February 18, 2021

**NOTICE OF ADDENDUM  
ADDENDUM NO. 2  
CONTRACT NO. 8572**

**GARVER PATH & STARKWEATHER DRIVE ASSESSMENT DISTRICT-2021**

Addendum No. 2, ID 5992-10-41  
 Revised sheet CD-1  
 02/17/2021

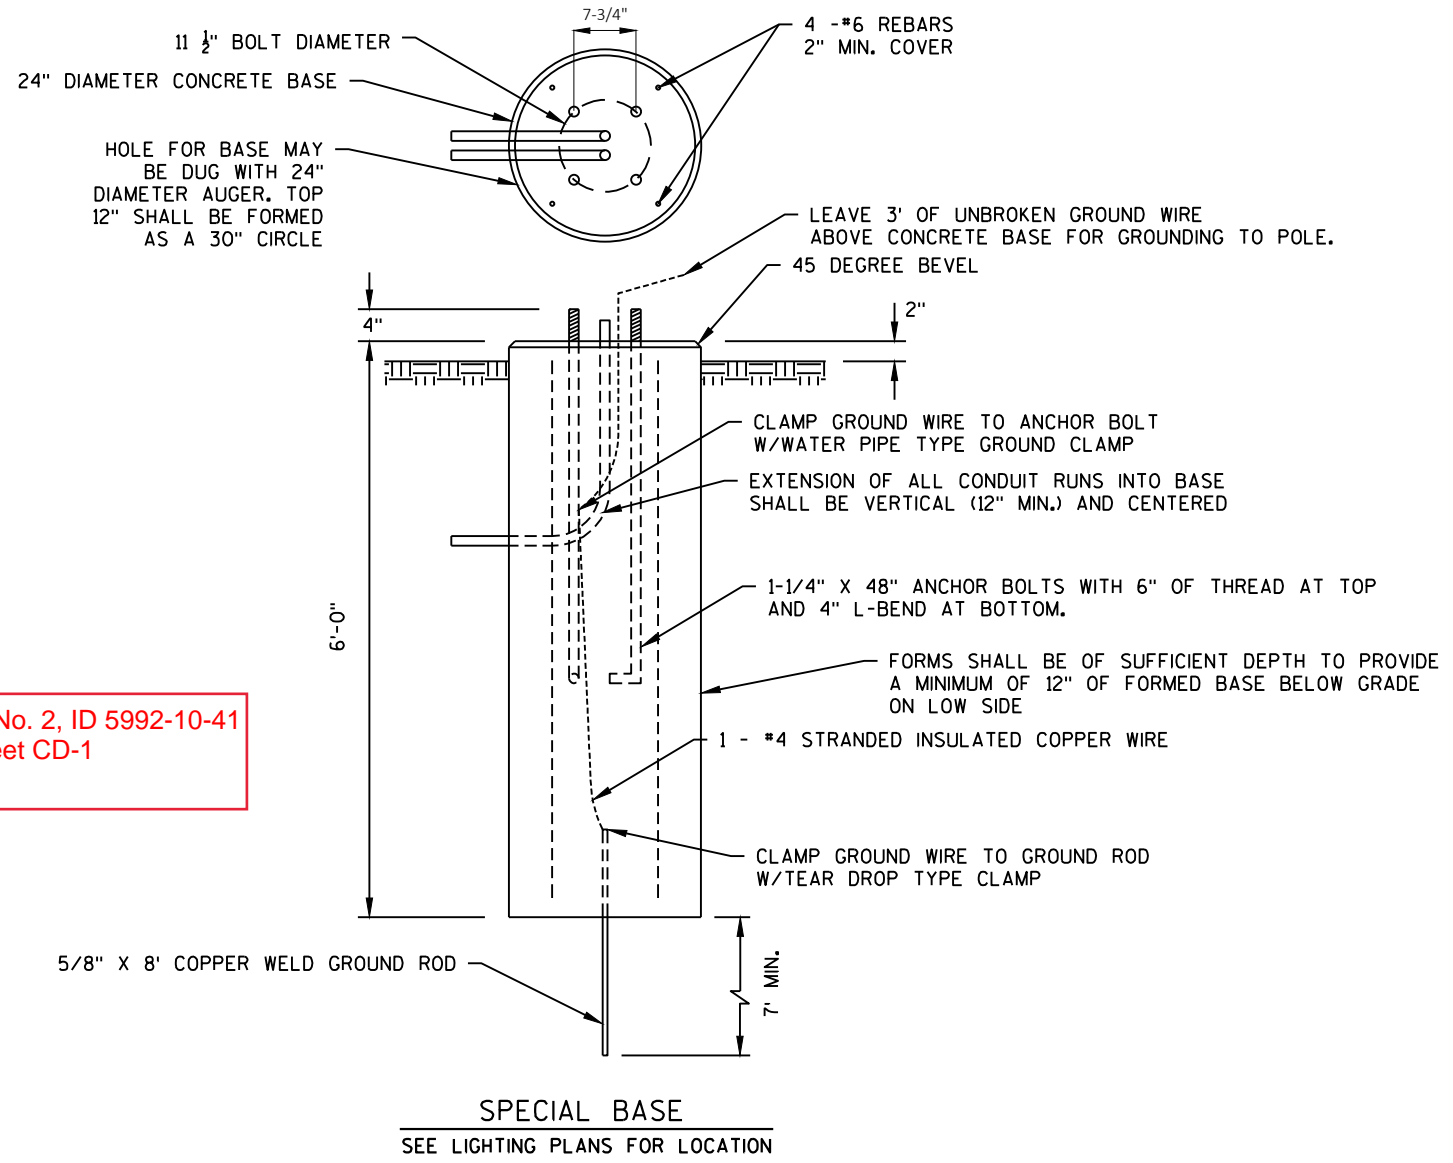
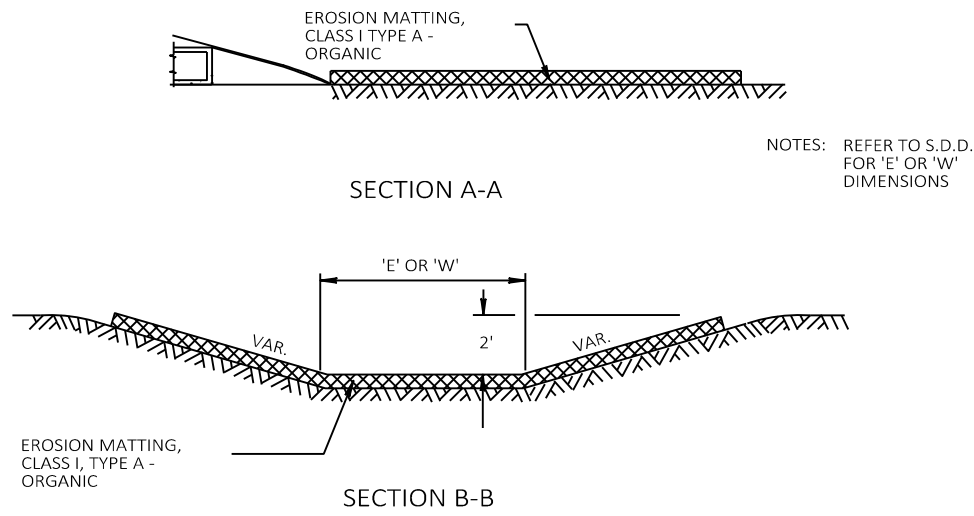
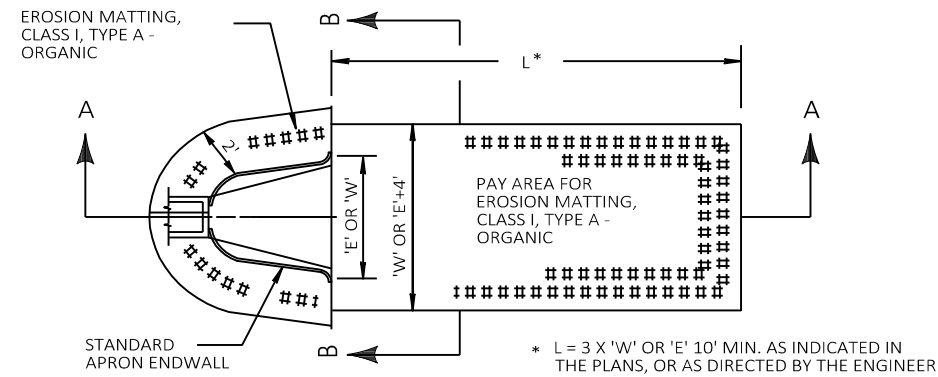
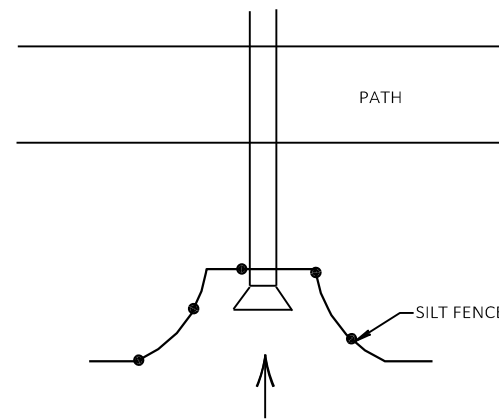
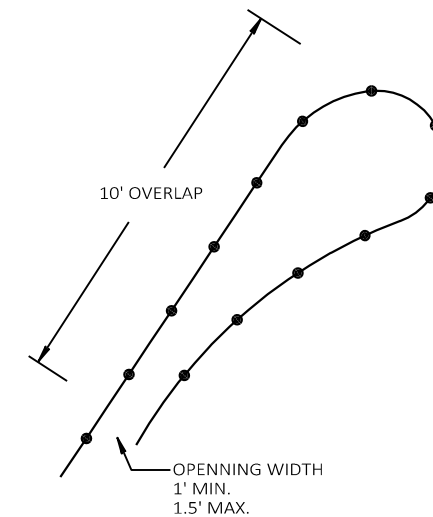
Sheet CD-1: Earthwork Summary added

Addendum No. 2, ID 5992-10-41  
Revised sheet S-1  
02/17/2021

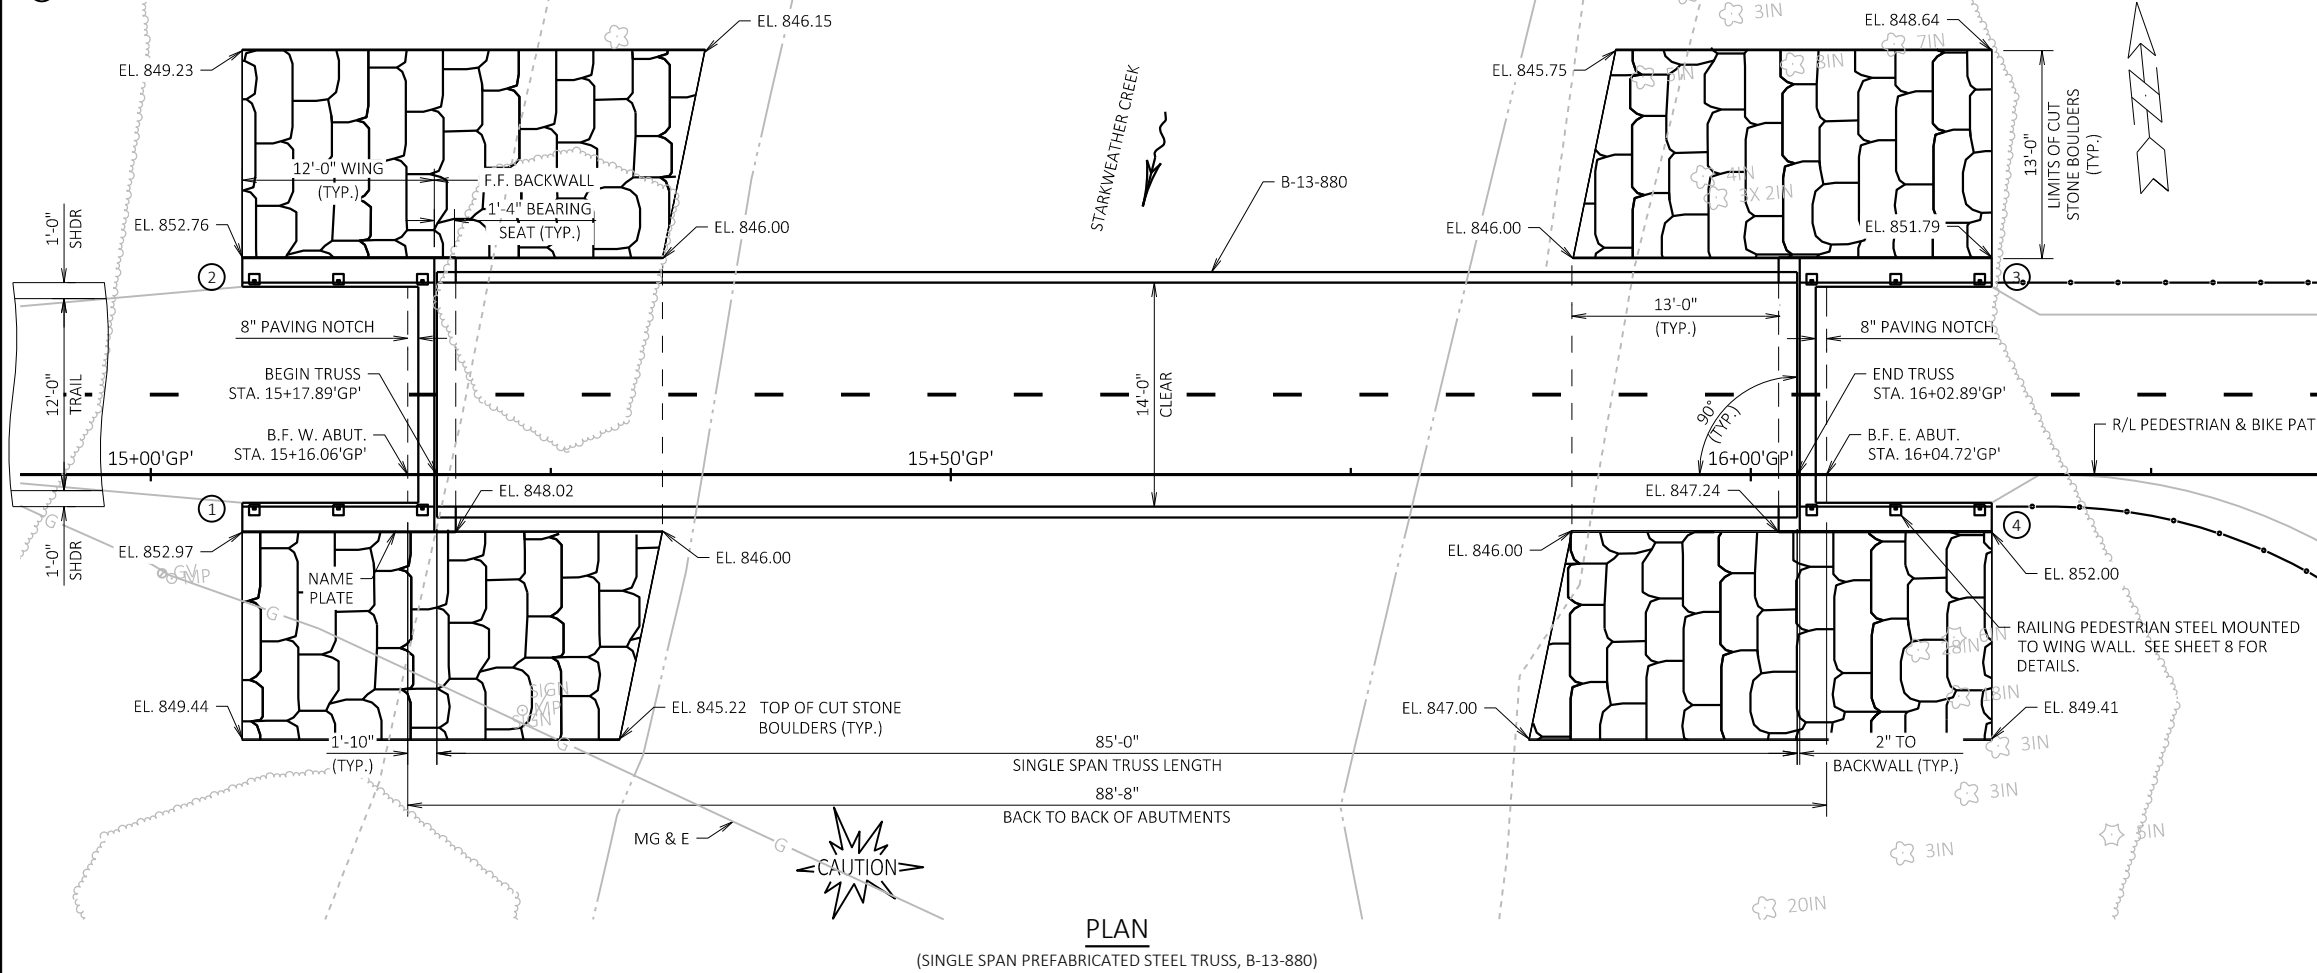
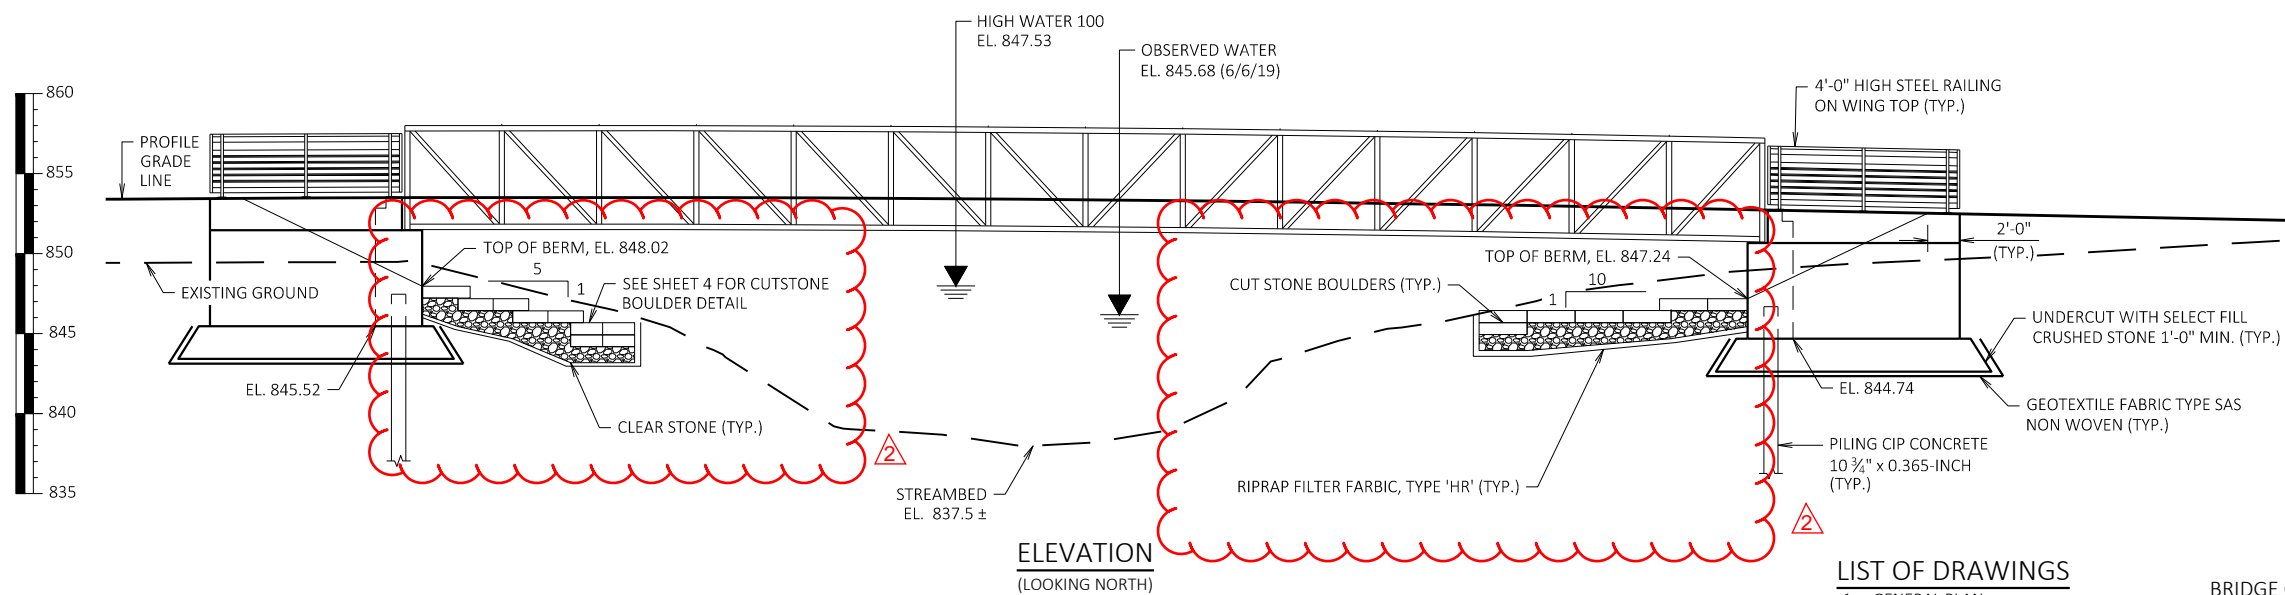
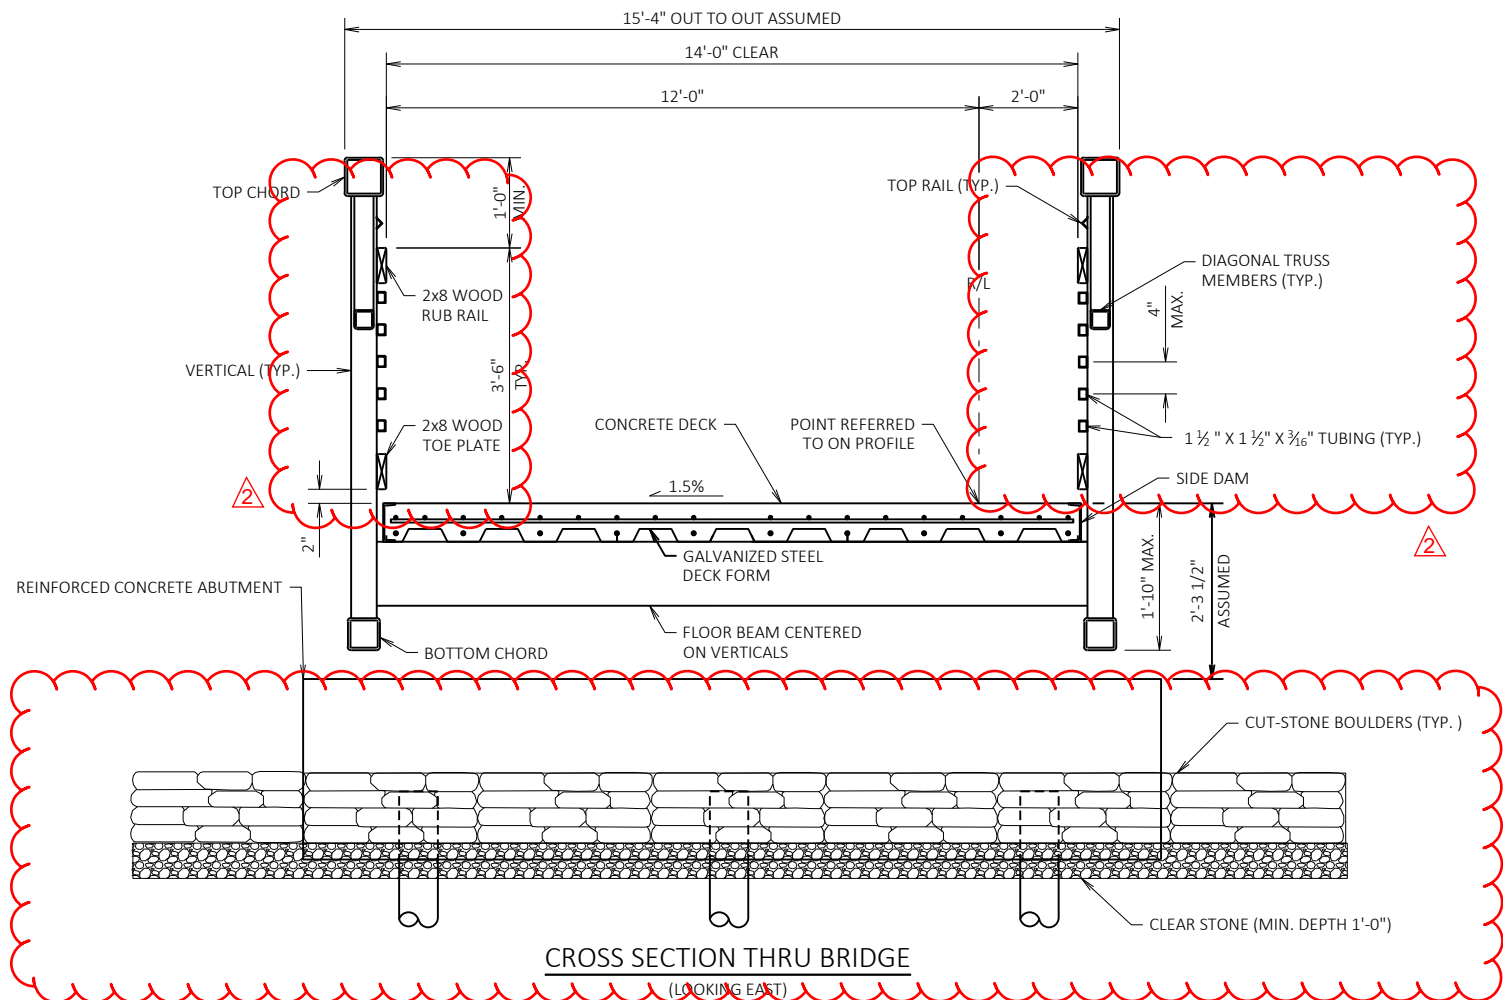
Sheets S-1, S-2, S-4, S-6, S-9, S-10, S-12, S-14 and S-18: Revisions include HSS tubing, lumber treatment, clear stone and revised quantities.
